GENERAL APPLICATION

Location Address: 6015 Washington Street Hollywood FL 33023

Explanation of Request: Request for site plan approval for the construction of 115 multifamily residential units & 750 square feet of retail space within a new 10-story building & related site improvements. Existing bank and office building to remain.

COMMENT RESPONSES

12 TYPICAL DUAL-PORT CHARGING STATION

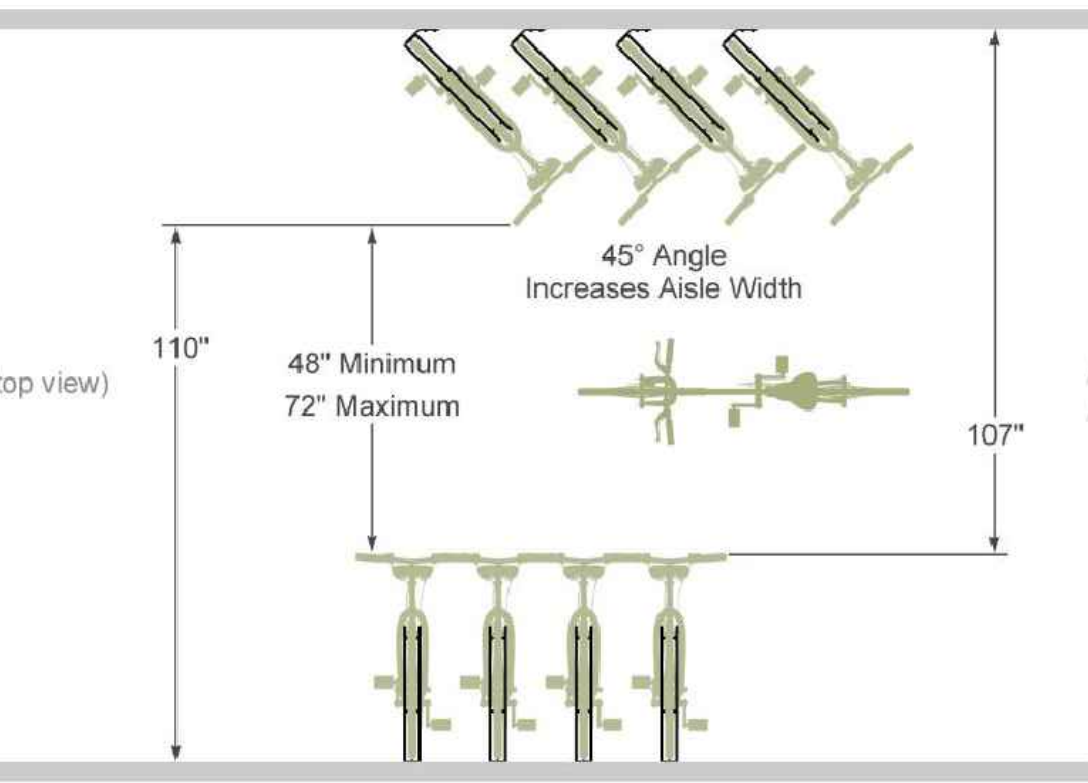
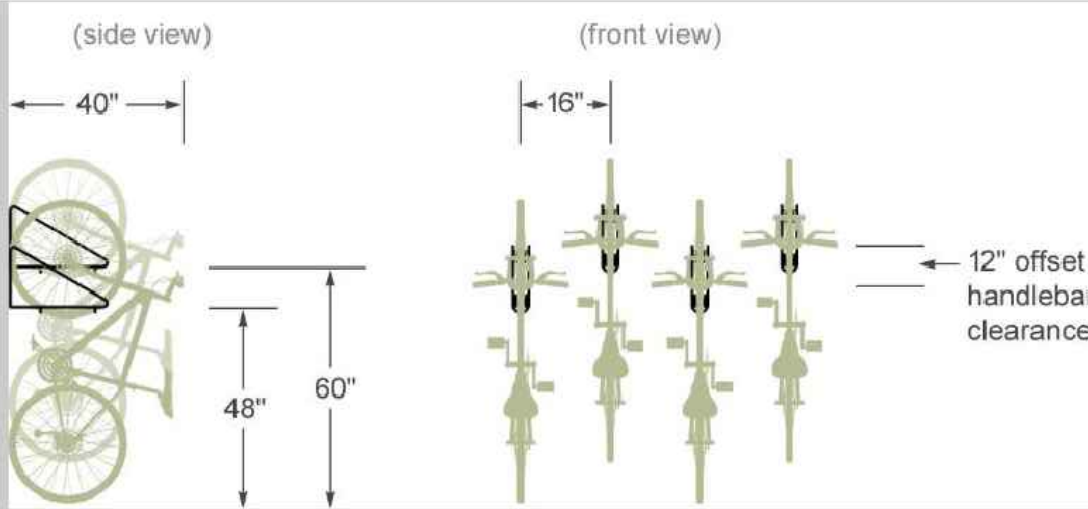
2. Indicate on the site plan where the infrastructure necessary for future installation of electric vehicle charging equipment will be located. (See 151.154, Ordinance O-2016-02) Consider placing it adjacent to a handicapped space so that the future charger will be accessible from both types of spaces.

RE: Electric vehicle charging equipment included in this proposal. Parking spaces shown in the floor plans. Refer to sheet A-100 thru A-103.

13 BIKE WALL RACK VERTICAL STORAGE

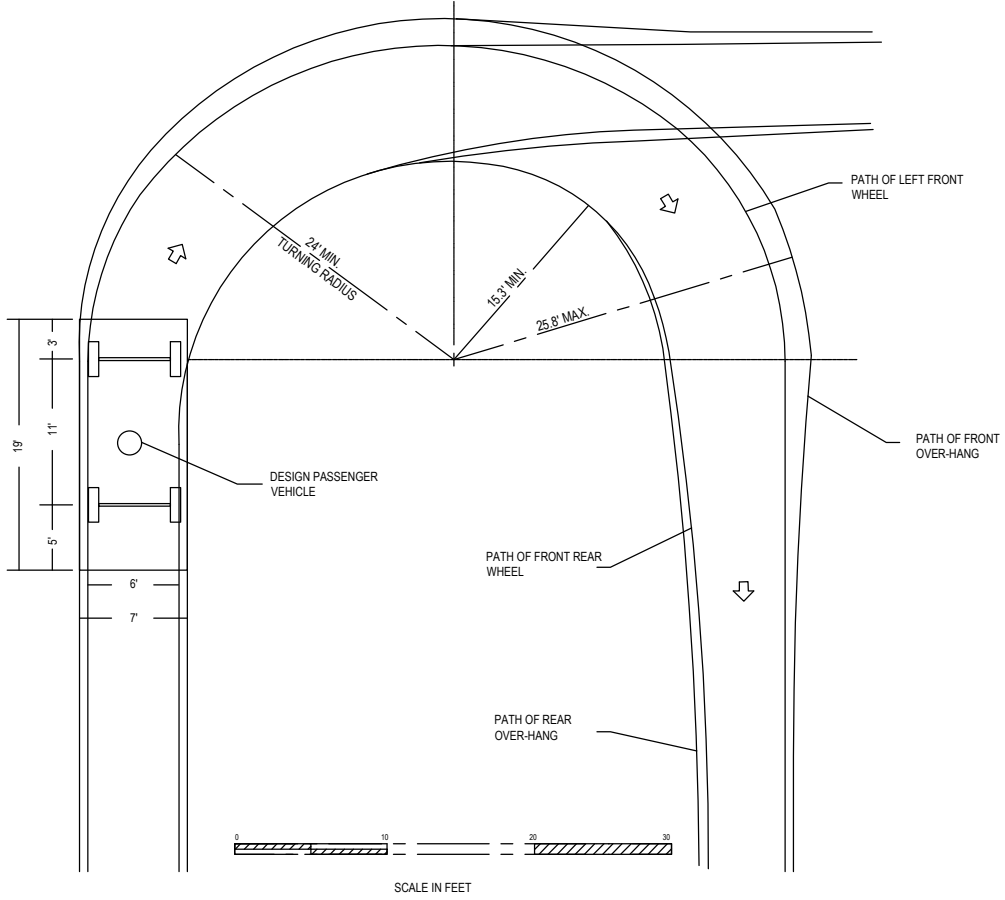
38. Provide a detail for the proposed bike rack.

RE: Comment addressed in this revision. Bike rack detail provided in the Site Plan Details, sheet SP-102

05 TYP. 4C MAILBOX DETAIL

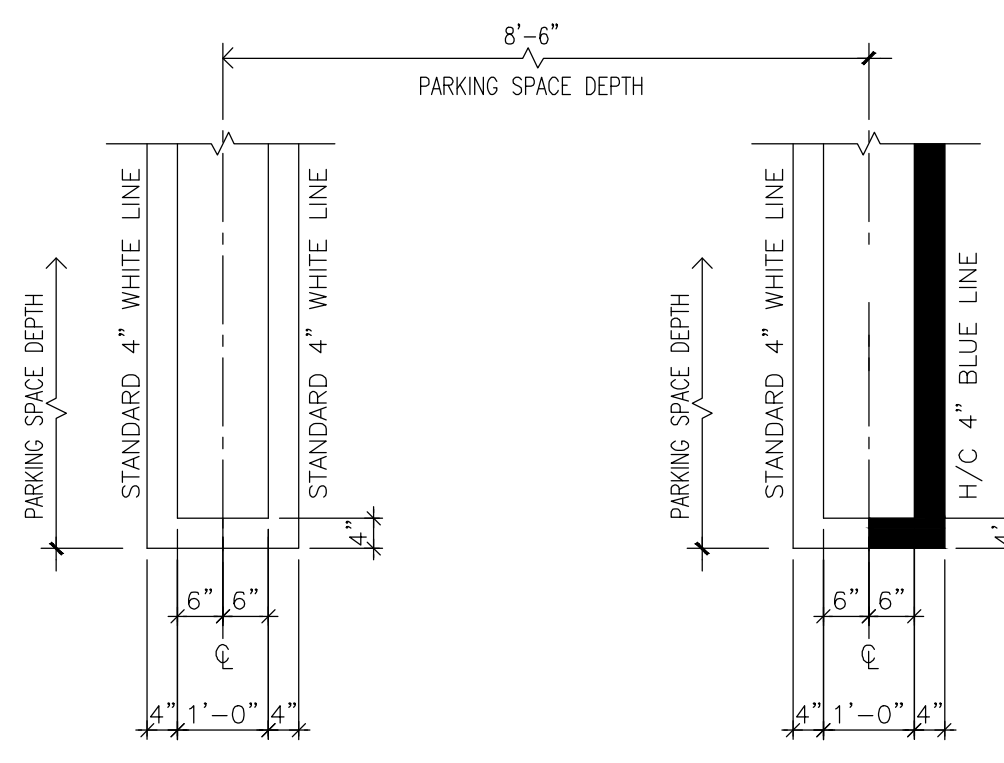
- 21) Indicate location of mailboxes / mail services on plan.

Response: Ground Floor Plan has been revised to show location of mail services.

PROJECT No. 202225
DRAWN BY:
CHECKED BY: CF
THIRD THRU FIFTH
FLOOR PLAN

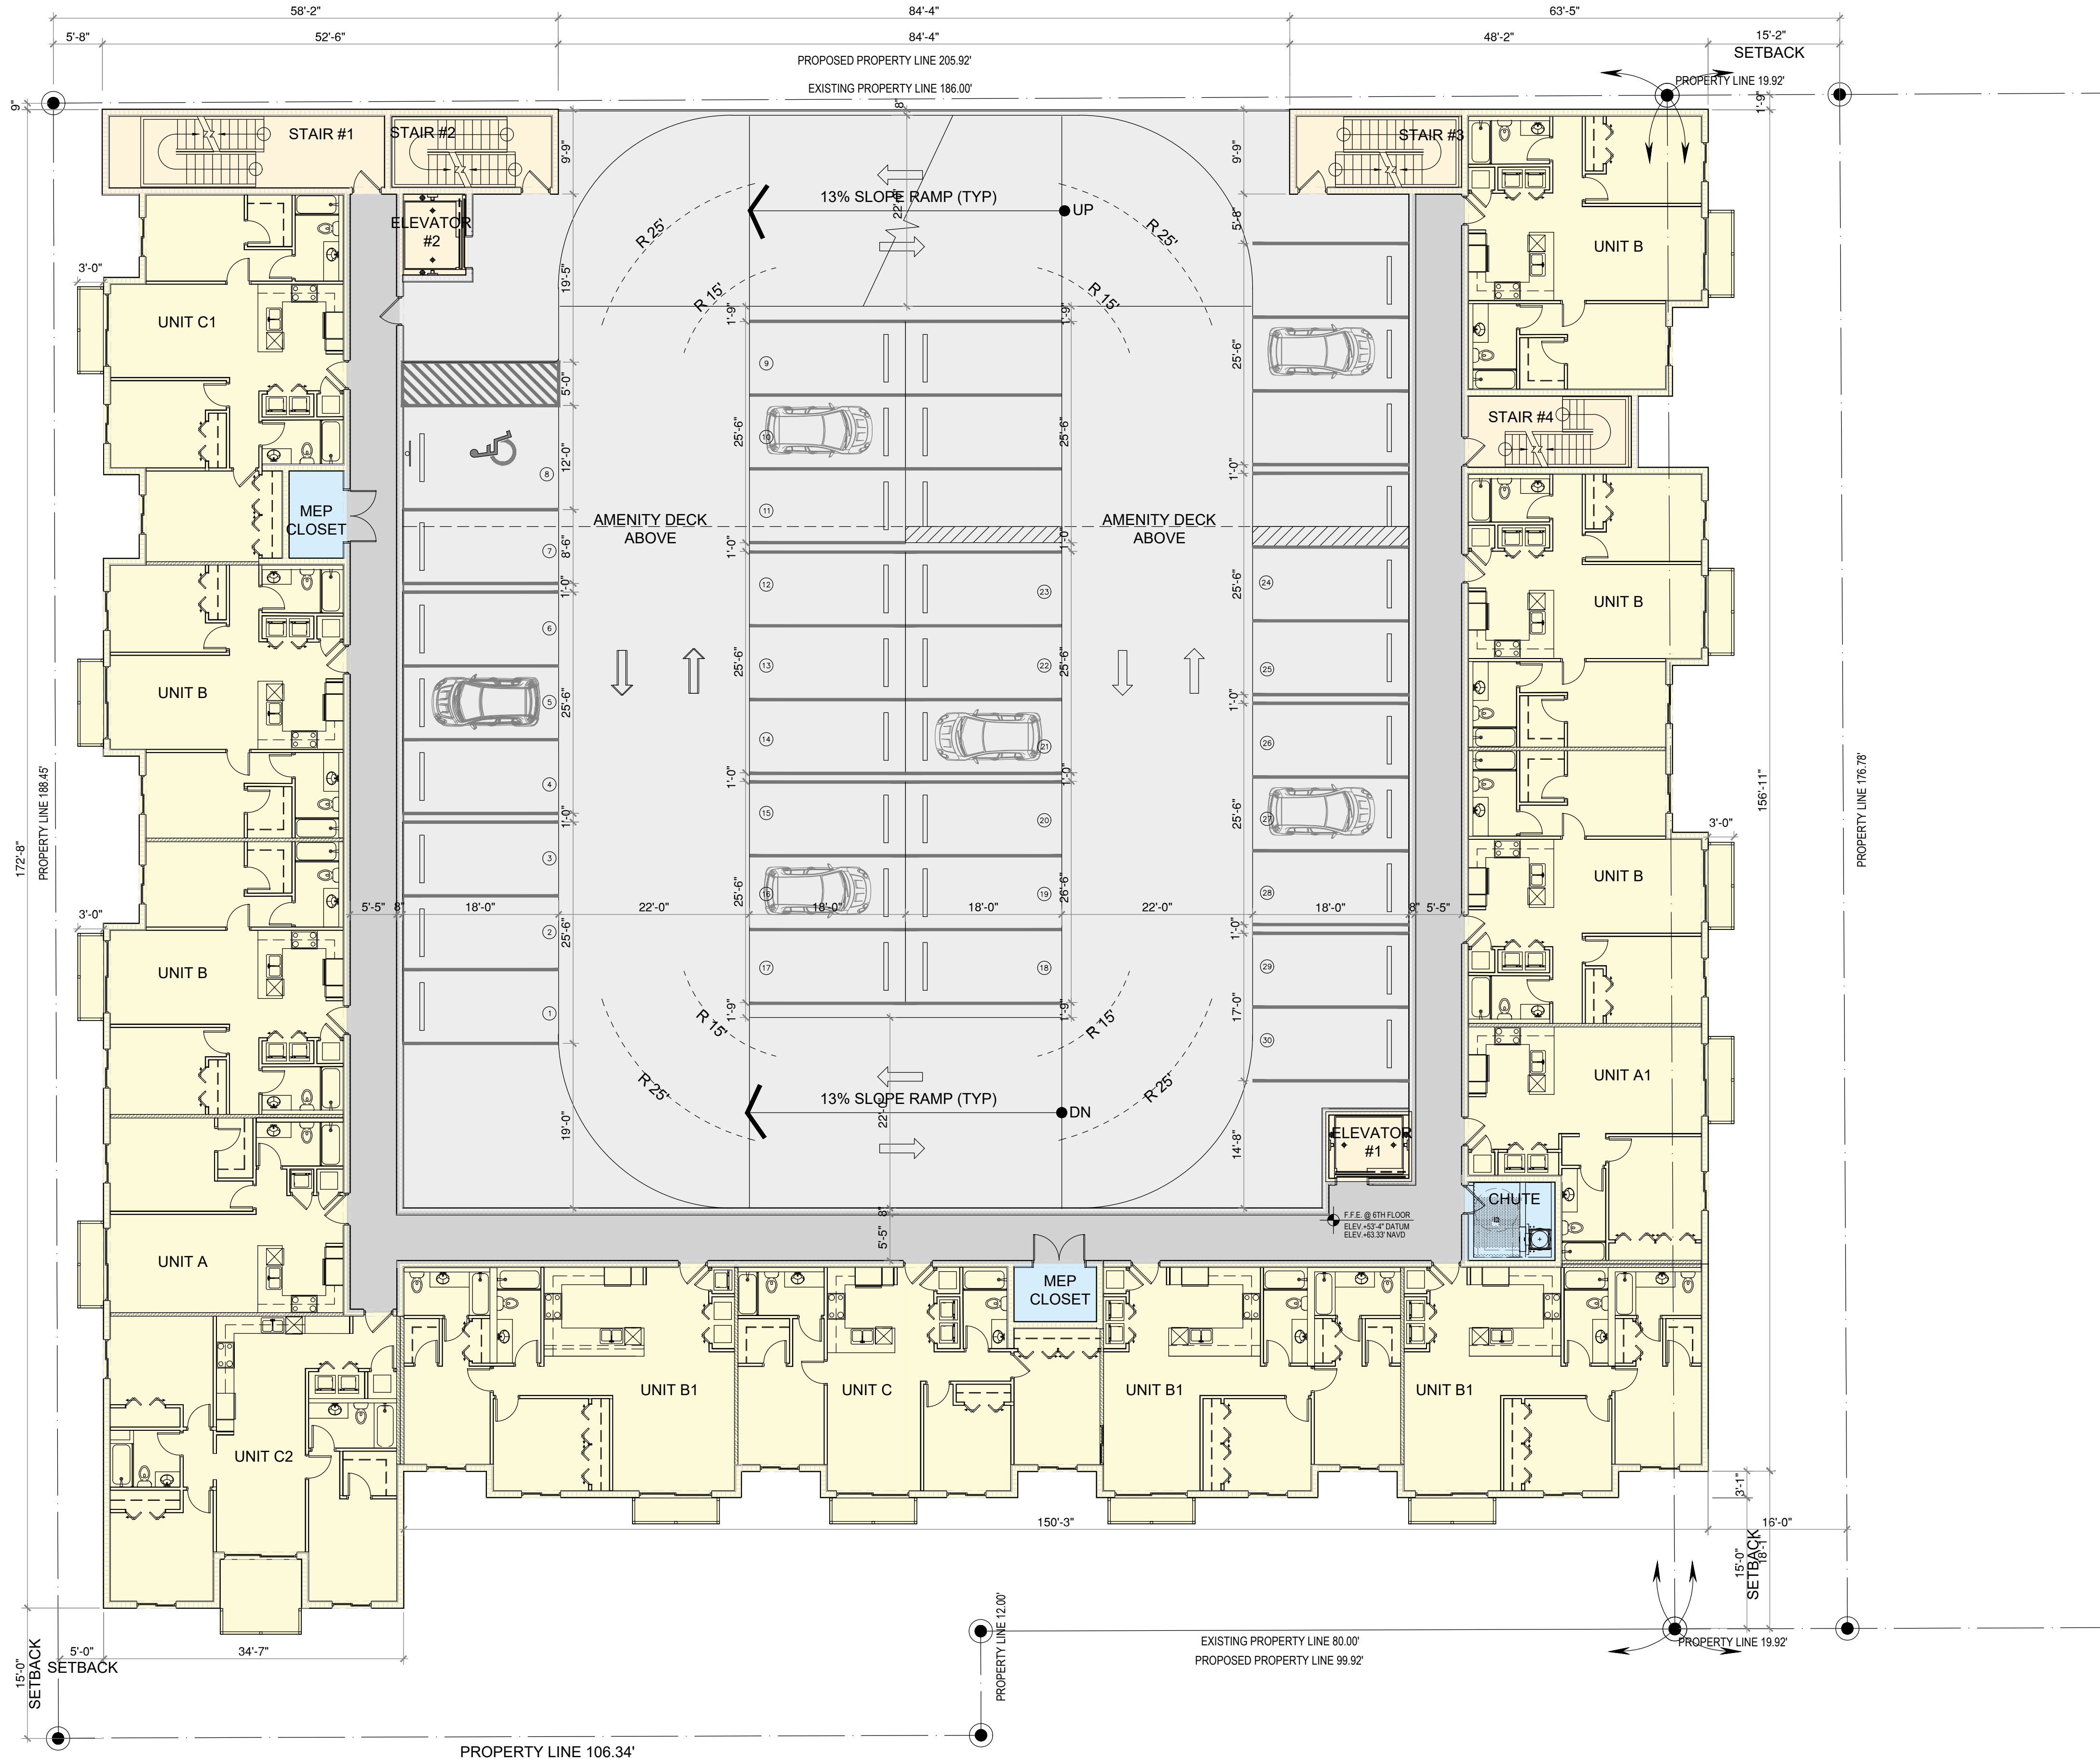
14. Sheet A-101 is for the 2nd - 5th floor, but the label in the middle of the garage is for the 3rd – 5th floor.

RE: Comment addressed on this revision.

SIXTH FLOOR PLAN
SCALE: 3/32"=1'-0"

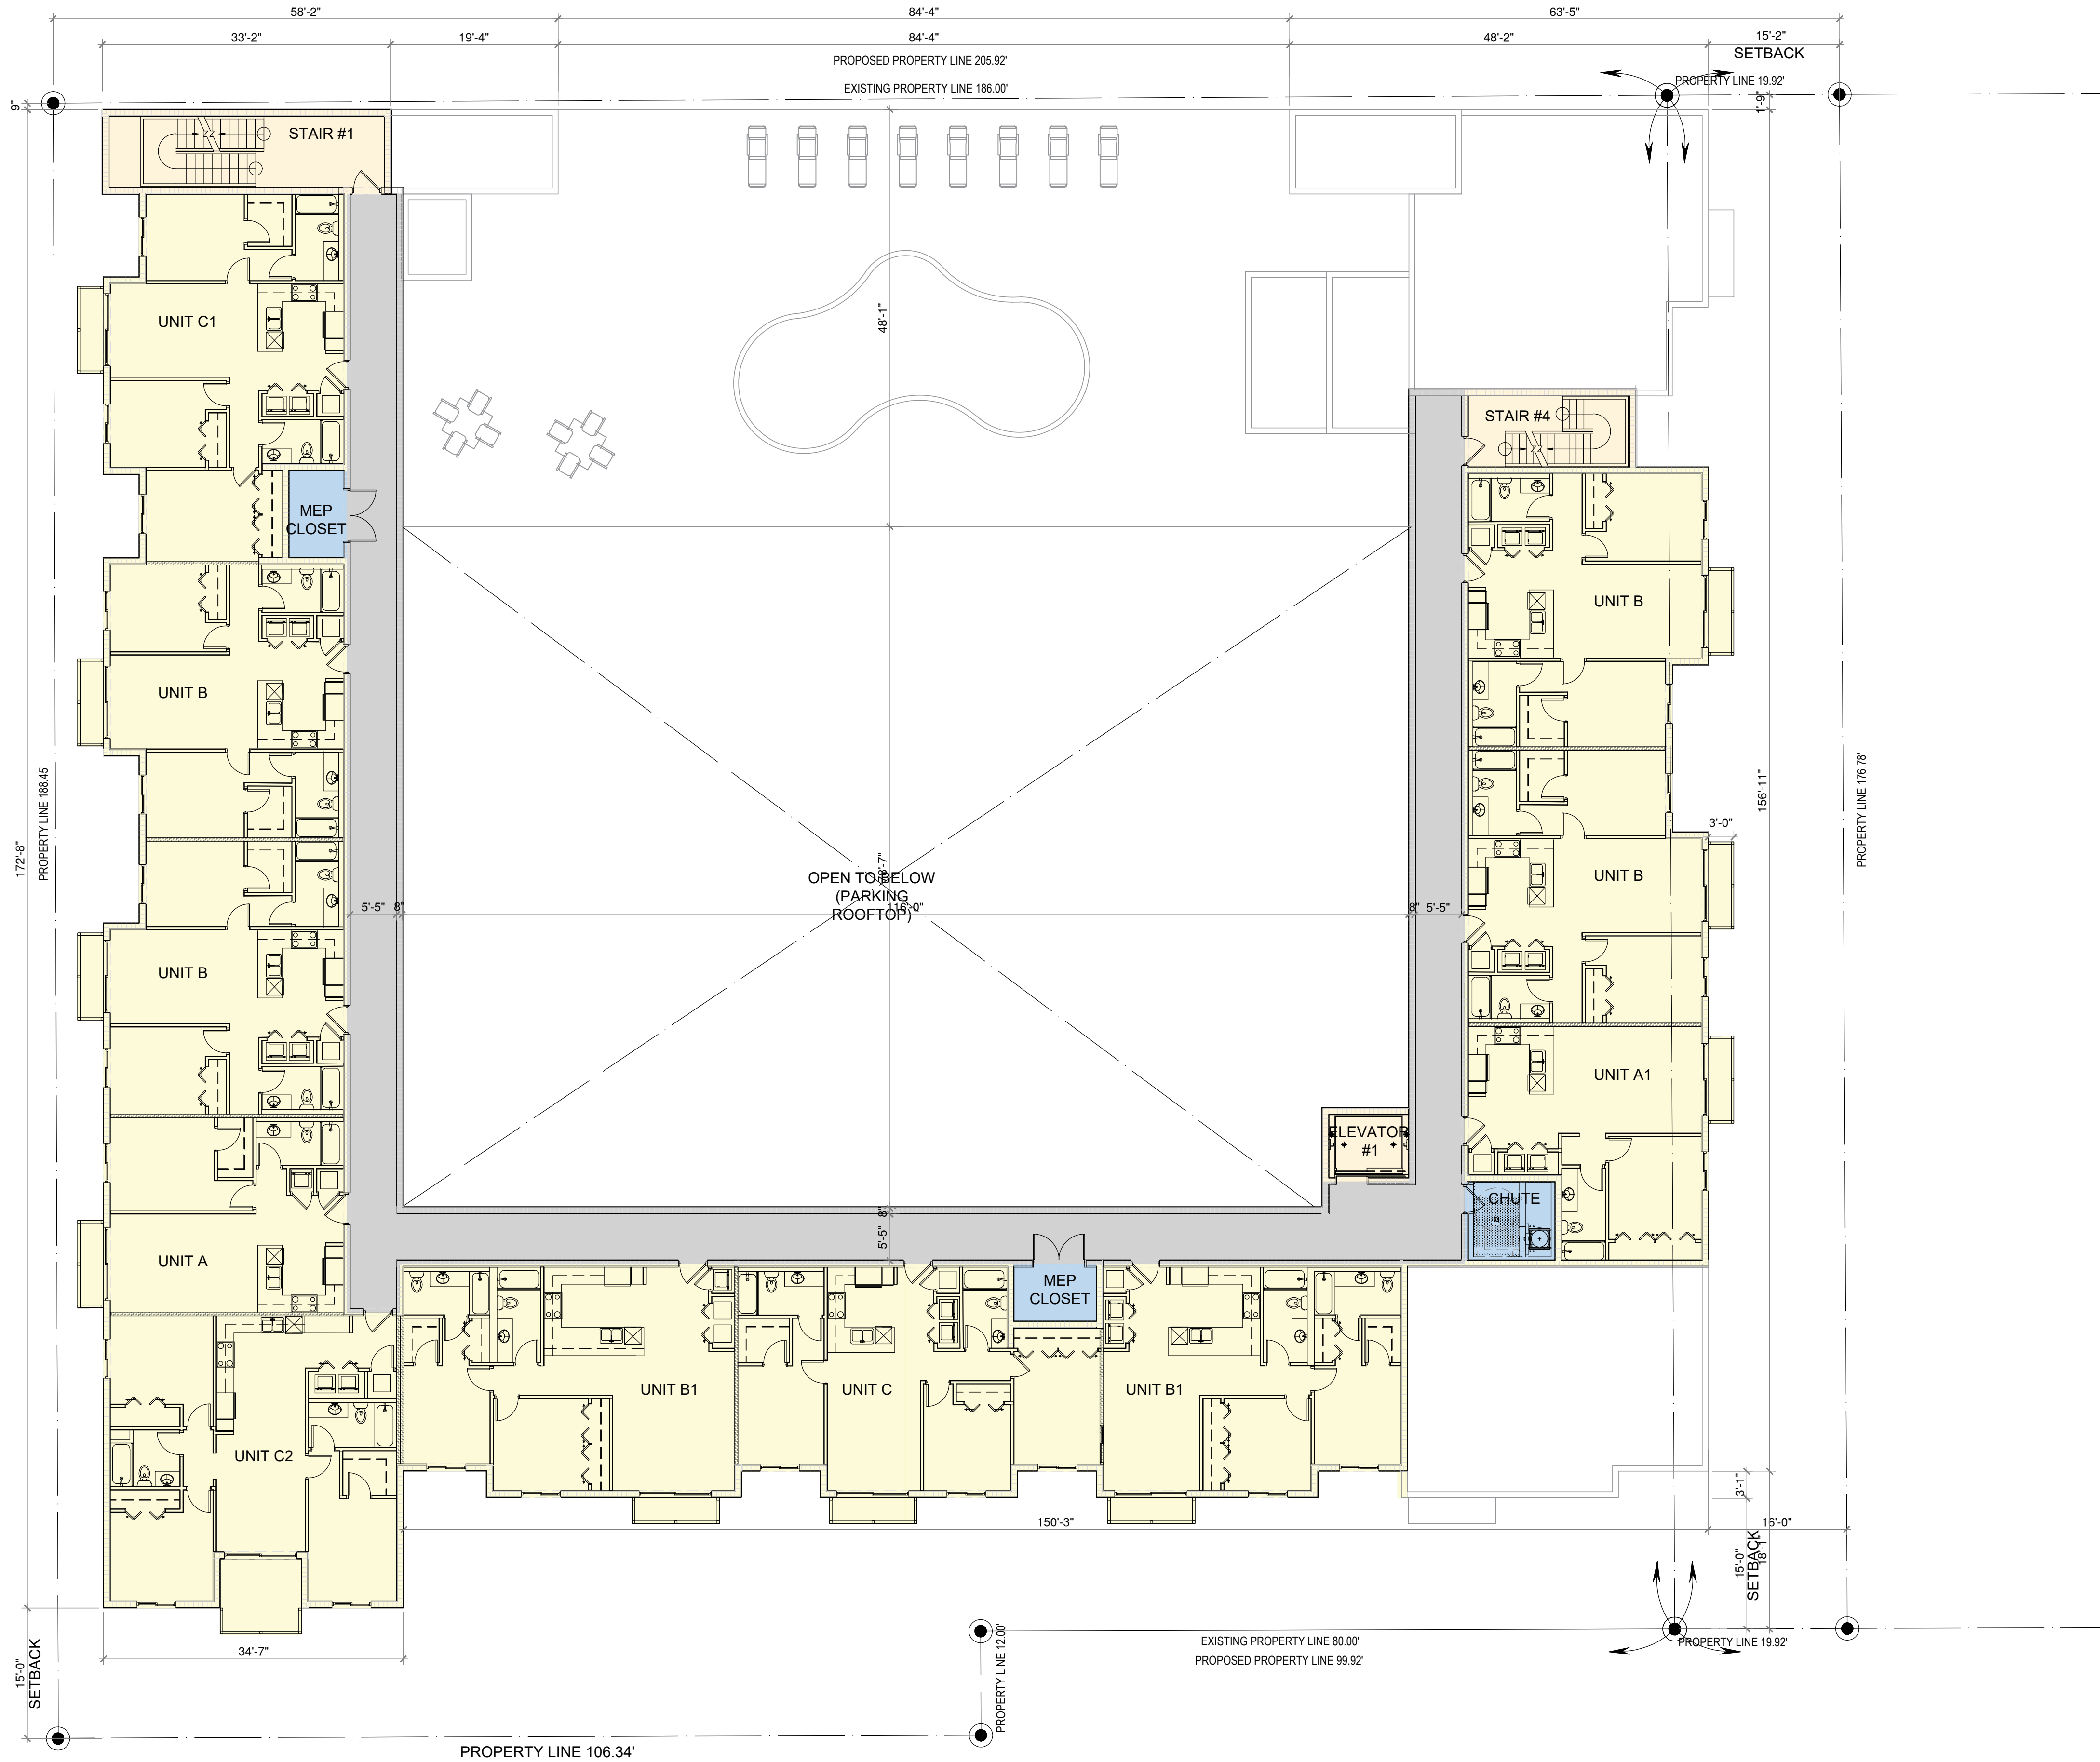
15. Identify the use of the area on the 6th floor (sheet A-102) and label all rooftop amenities. The upper floors also show a similar layout, however if this is meant to be “open to below”, state same on the floor plans.

RE: Amenities have been labeled. “Open to below” is shown on all pertaining plans from 8th floor through roof.
